DEPARTMENT OF TRANSPORTATION

[Docket No. NHTSA 2001–11041, Notice 2]

Toyota Motor Corporation, Denial of
Application for Decision of
Inconsequential Noncompliance

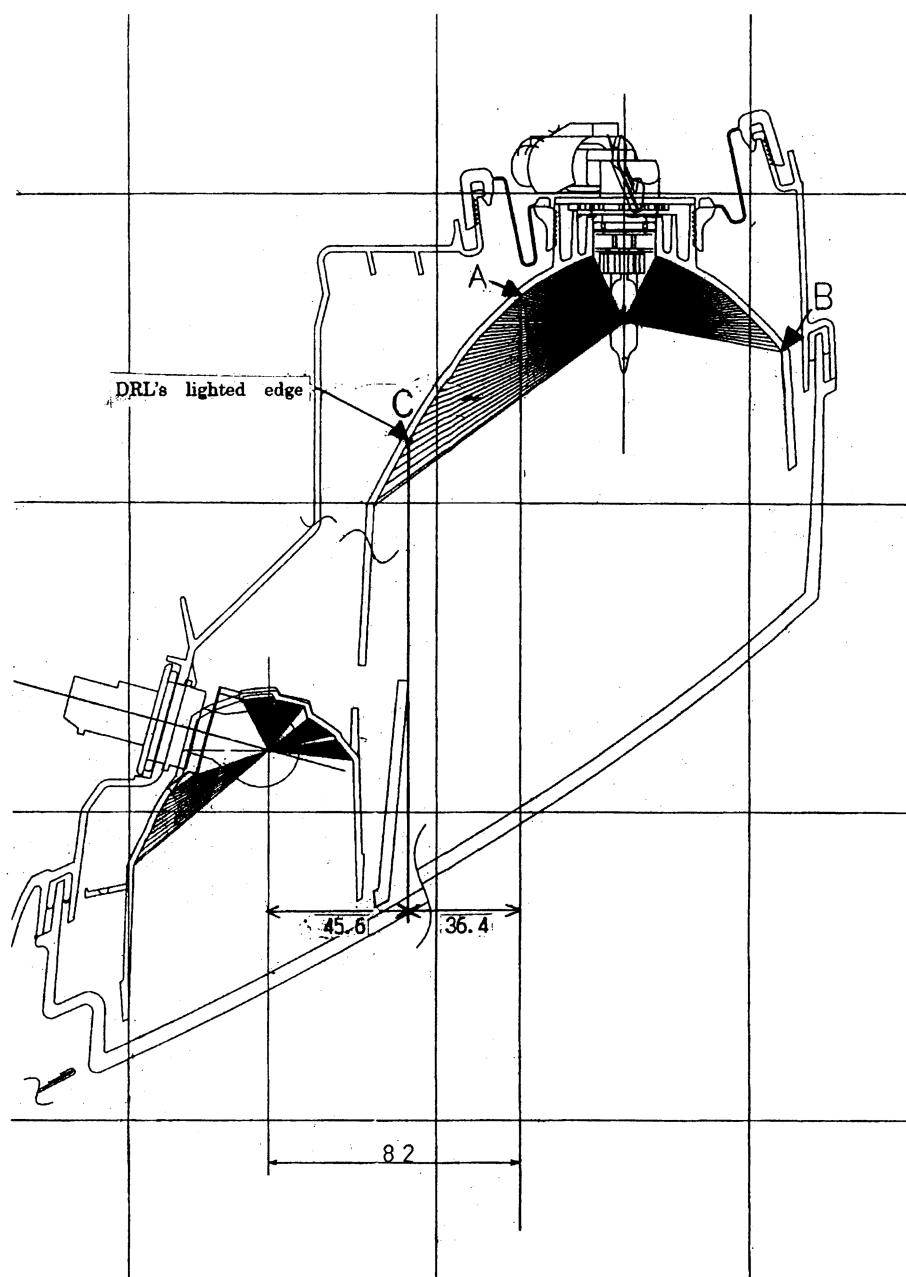
The substantial distance from the turn signal optical center (bulb filament axes) to the DRL’s lighted edge is 82 mm, exceeding 80% of the requirements. In this case, the “substantial” distance refers to the distance from the turn signal’s optical center to the actual lighted edge “A” [as shown in the figure below], although the theoretical lighted edge is point “C” (45.6mm). In [the figure below], the lighted range from A to C of the reflector emits only light which is parallel to the axis of the DRL, which can only be seen by drivers in oncoming vehicles that are looking along the optical axis of the DRL. However, as one moves off center, this light is no longer visible. Therefore the perceptible DRL’s lighted area, except for the unique case where the eye-point is on the optical axis of the DRL, is actually from A to B (as shown in the figure).

Toyota also discussed an alternative method of measuring the distance between the DRL's lighted edge and the optical center of the turn signal. The above figure outlines these two spacing measurements. Toyota stated that the spacing of 45.6 mm between the DRL's lighted edge and the turn signal's optical center (line C to the optical center) would only be seen when looking along the optical axis of the DRL. In other positions, the DRL's lighted edge (line A) would be seen by observers as being 82 mm from the turn signal's optical center. The agency does not find merit in this rationale. First, the distance measured from line A is 18 mm less than the minimum requirement. This is still a significant difference. Second, although the distance from line C to the turn signal's optical center (45.6 mm) may not best represent the DRL's lighted edge in all conditions, it does represent a worst-case scenario. The intent of the standard is to account for all possible viewing locations. Certainly, there will be situations where opposing drivers will be looking along the optical axis of the subject vehicles' DRL. For example, if a vehicle is attempting to make a left turn in front of oncoming traffic, drivers of the oncoming vehicles may be in a position where the turn signal is not visible. Mr. Johnson described a similar situation in his comments.

The agency has reviewed Toyota's rationale for granting the petition and does not agree. Toyota produced almost 100,000 vehicles on which the required spacing between the DRL and turn signal is approximately 55 percent below the minimum required distance. The agency notes that the noncompliance would not have occurred if the DRL had an intensity of 2,600 cd or less. However, Toyota chose not to do this.

In consideration of the foregoing, NHTSA has decided that Toyota has not met its burden of persuasion that the noncompliance it describes is inconsequential to motor vehicle safety, and that it should not be exempted from the notification and remedy requirements of the statute. Accordingly, its application is hereby denied and it must proceed to notify and remedy as required by statute, at no cost to the consumer.
